Company	Trenz Electronic GmbH
PCN Number	PCN-20240207
Title	Pull-up resistor removal for signal "MR"
Subject	BOM Change
Issue Date	2024-02-07

2.1 #1 Pull-up resistor (R82) removal for signal "MR"

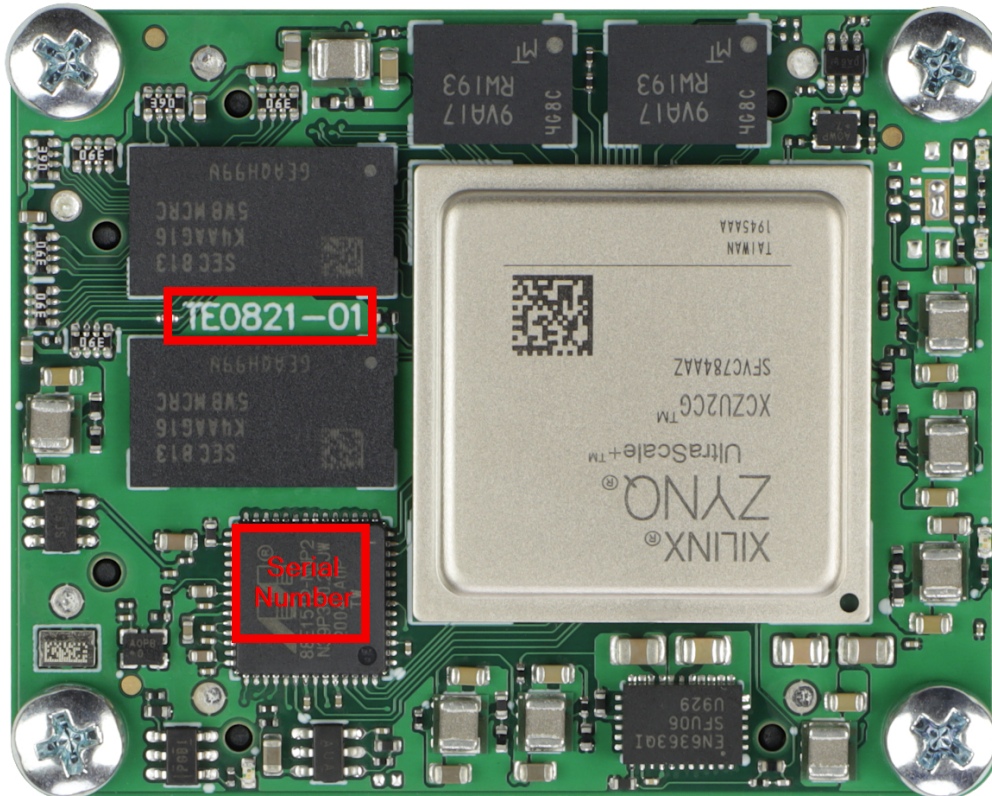
Type: BOM Change

Reason: Boot procedure improvement.

Impact: None, U19 has internal pull-up resistor. Improved boot procedure.
